### **Amendments to the Drawings**

## REMARKS

Fig. 1

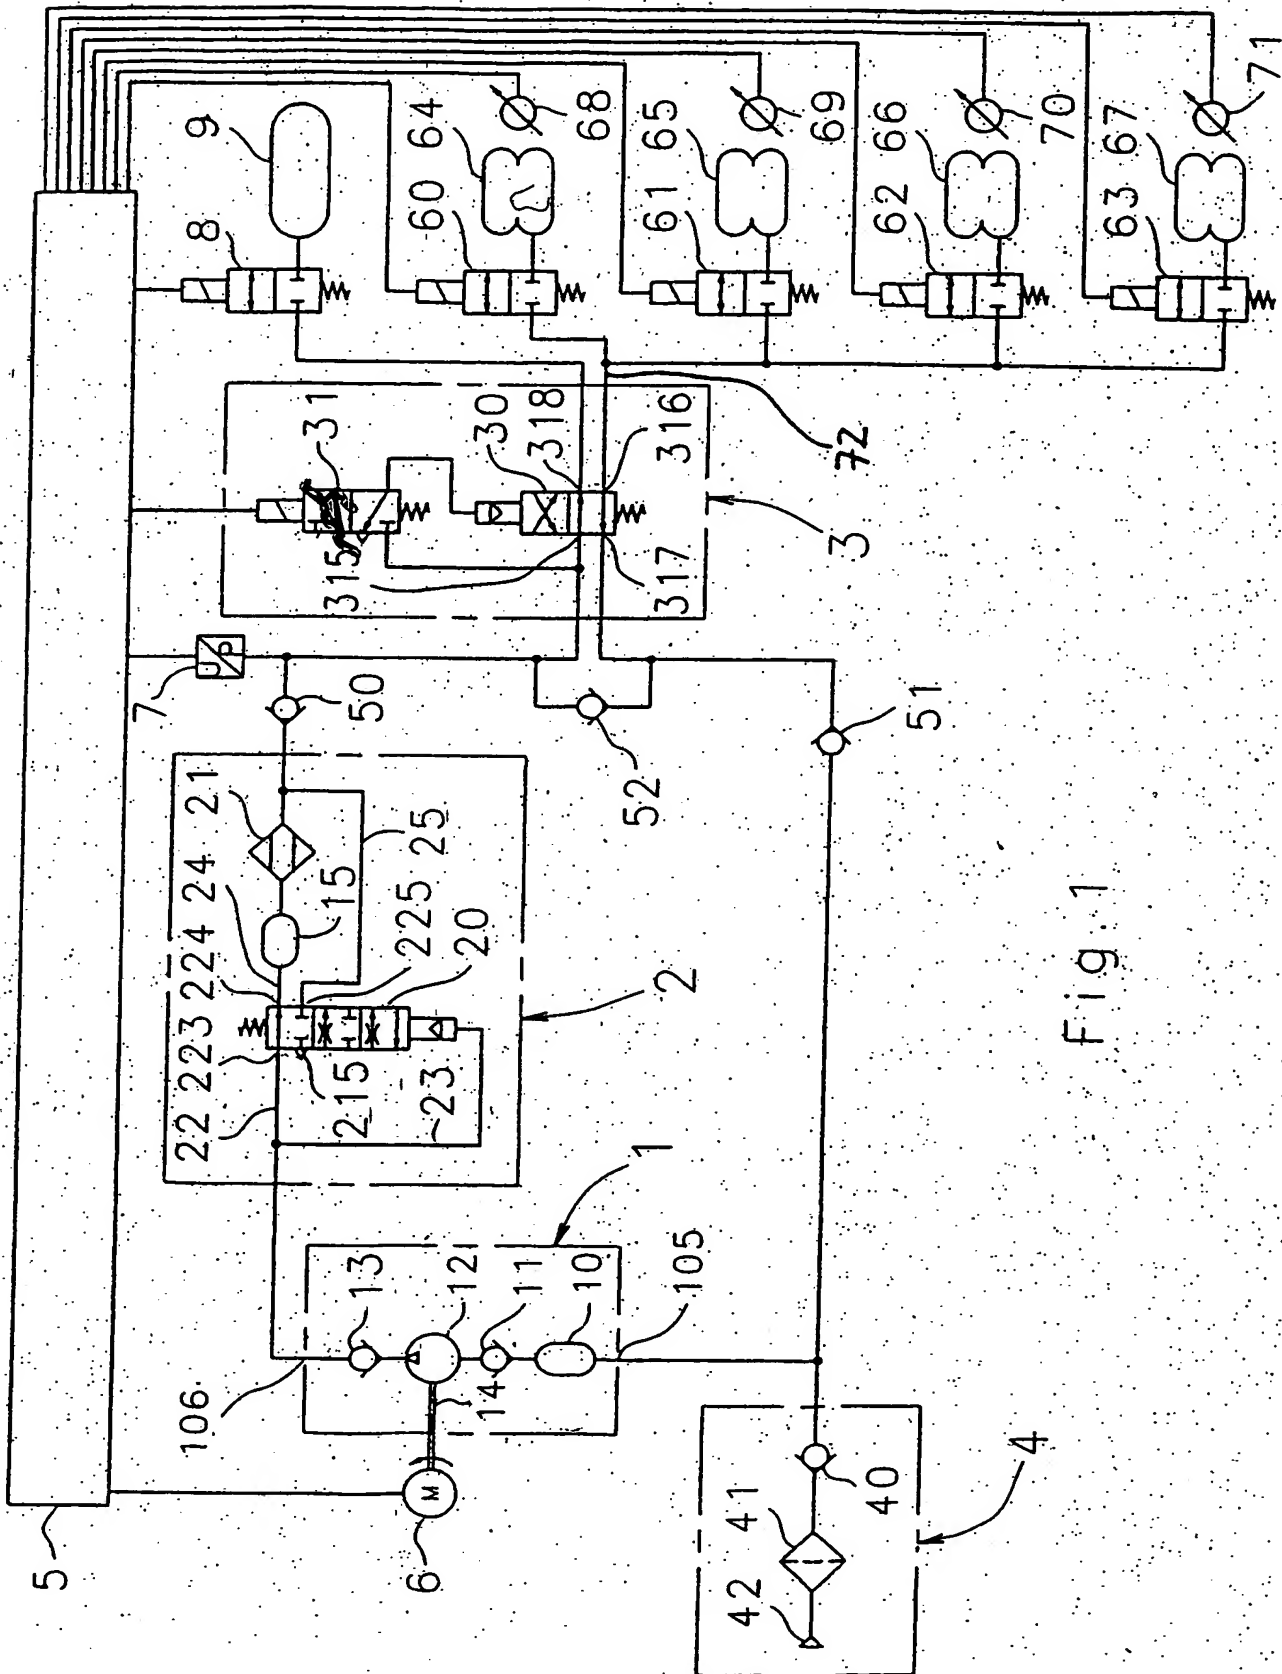
The attached Replacement Sheet includes changes to Fig. 1 and replaces the original Fig. 1. Valve 31 of Fig. 1 has been revised to conform to the application specification with respect to illustrating fluid flow therethrough. More particularly, the arrow in the top position of valve 31 symbolizing fluid flow has been revised to extend horizontally from left to right rather than at an upwardly extending angle. No new matter has been introduced.

In the Office Action, the Examiner objected to the drawings as containing informalities. Specifically, the Examiner stated that valve 31 in FIG. 1 does not comport with the application specification with respect to fluid flow therethrough in that the valve ports do not align properly. In accordance with the approval of the Examiner during the recent telephone conference, FIG. 1, specifically valve 31, has been revised to align the ports to illustrate fluid flow as described in the specification. No new matter has been introduced.

In addition, the Examiner objected to the drawings as failing to include arrows on the lines to and from parts 7, 69-71, 6, 8, 3 and 60-63 in FIG. 1 showing direction of flow of fluid or information. As discussed during the telephone conference and agreed to by the Examiner, this requirement is unnecessary because the aforementioned parts allow for bidirectional flow of fluid or information as the case may be. *See* paragraphs [0033] - [0038].
